A46 Newark Bypass

TR010065/APP/6.2

**7.36 Supporting Historic Environment and Visual Impact
Assessment**

| Version | Date | Status of Version |
|----------------|---------------|--------------------------|
| Rev 1 | November 2024 | Deadline 2 Submission |

Photomontage 25: Existing view (cylindrical projection, field of view 90 degrees x 27 degrees, to be viewed at A1)

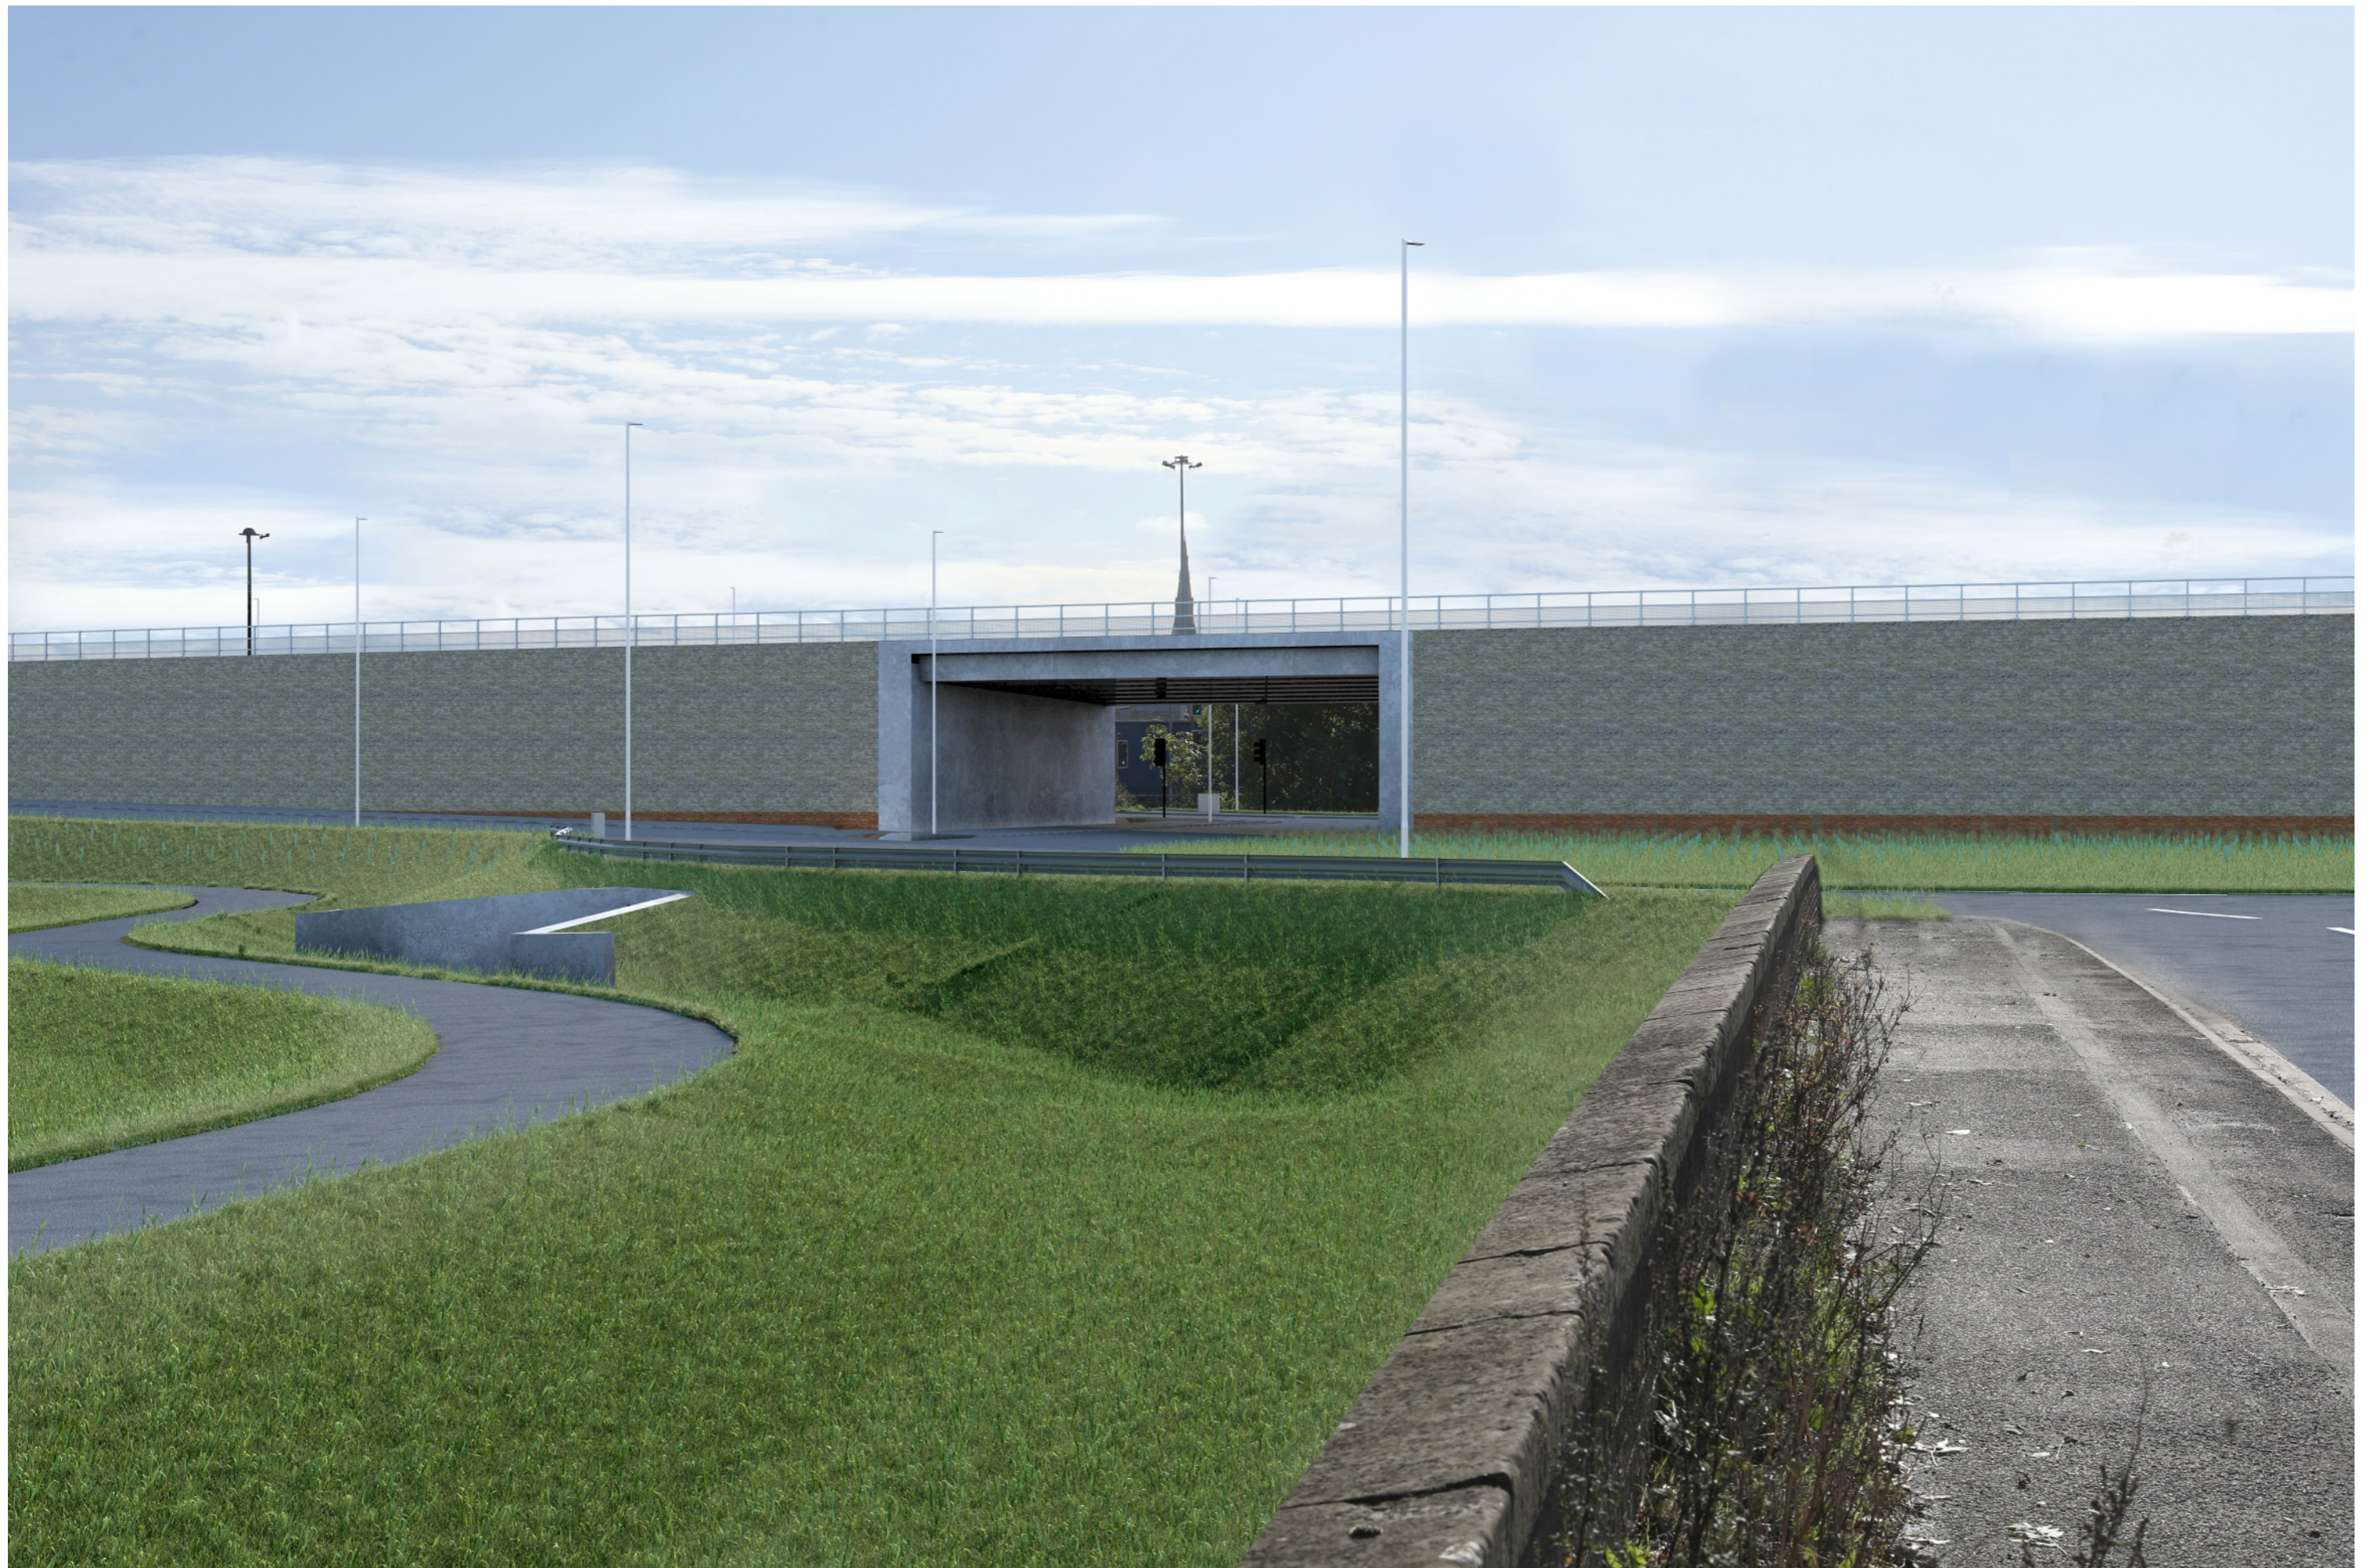
- A wireframe to support the analysis of the potential impacts on Newark Castle from VP 18 of figure 7.4 – Visual Receptor Location Plan [AS-040] to achieve a clearer understanding of the long-term effects on views out from the castle. This should be to a 180-degree view with three hard copies provided to the ExA.*
- The approach into Newark from the Cattle Market junction as identified at VP 25 of figure 7.4 – Visual Receptor Location Plan [AS-040] is considered a Key Visual Receptor given the associated views of Newark Castle and St Mary Magdalene Church and the experience of entering the town via the Smeaton Arches. The Applicant should identify VP 25 as a Key Visual Receptor and provide three hard copies to the ExA of the photomontage.”*

1.3 Viewpoint 25 – additional photomontage

1.3.1 The request for Viewpoint 25 to become a key visual receptor has been addressed by the applicant and updates subsequently made to Figure 7.4 - Visual Receptor Location Plan [AS-040] and 6.2 Figure 7.5 - Visual Effects Plan [AS-041] of the Environmental Statement.

1.3.2 Viewpoint 25, representative of views from Great North Road looking south, was re-visited on 10 October 2024. However, in order to ensure the photomontage is representative of the view experienced from Great North Road at Smeaton’s Arches, as per the Rule 6 request, the new photograph has been taken further south of VP 25 as denoted in Appendix B of this report. A new photomontage has been created at this location at 90 x 27 degrees and 39.6 x 27 degrees field of view as per the landscape institute specification.

- 1.3.3 The photomontage is contained in Appendix B of this document and presents the likely change in view during Year 1 and Year 15 of operation when looking south from this location towards the Scheme.

Photomontage 43A: Existing view (cylindrical projection, field of view 90 degrees x 27 degrees, to be viewed at A1)

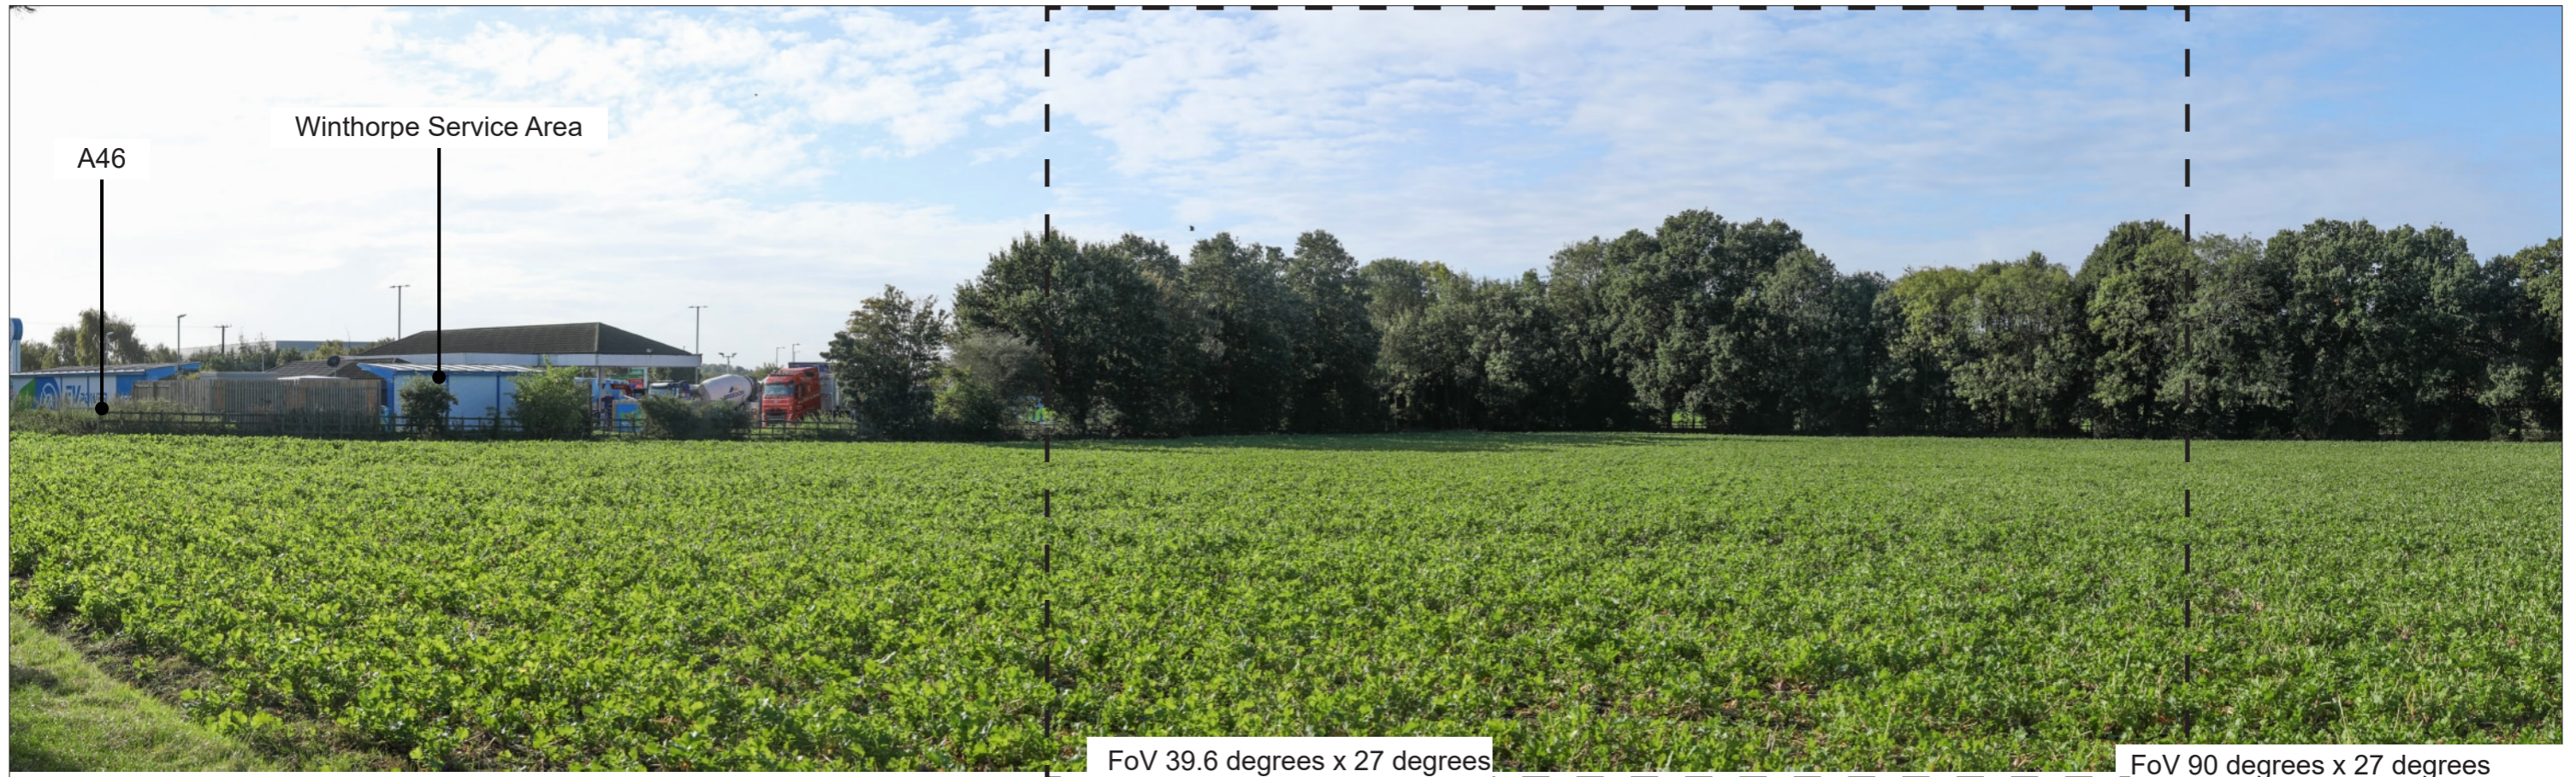
“[...] However the LPA considers that there has been insufficient information showing the experience from within the Winthorpe Conservation Area and the effect of the new Brownhills junction and specifically the flyover, would have on it. Therefore we ask that you consider a visit and request a photomontage from the fields around VP42 or VP43 looking in a south westerly direction towards the new junction (see below). It is accepted that the site is heavily landscaped in this area and from the Arboricultural reports and plans, these trees are to remain. However the highly elevated position of the new flyover and the sensitive nature of the CA designation would mean that it is particularly vulnerable to change, especially by harsh infrastructure such as is proposed. VP43 which is along the existing footpath (Winthorpe FP2), the LPA does not agree that it effectively covers a sufficient area to be a true reflection of the actual impact, hence our request”.

- 1.6.1 As per the request made by NSDC, an additional photomontage has been prepared to illustrate the potential impacts upon Winthorpe Conservation Area. The photomontage has been produced from the southerly tip of the Conservation Area looking west towards the A1. The location and angle of view captured within the photomontage have been agreed with NSDC. A photograph was taken from PROW Winthorpe FP2 on 10 October 2024, with the photomontage created at 90 x 27 degrees and 39.6 x 27 degrees field of view as per the landscape institute specification.
- 1.6.2 The photomontage is contained in Appendix D of this document and presents the likely change in view during Year 1 and Year 15 of operation when looking west from this location towards the A46 and A1.
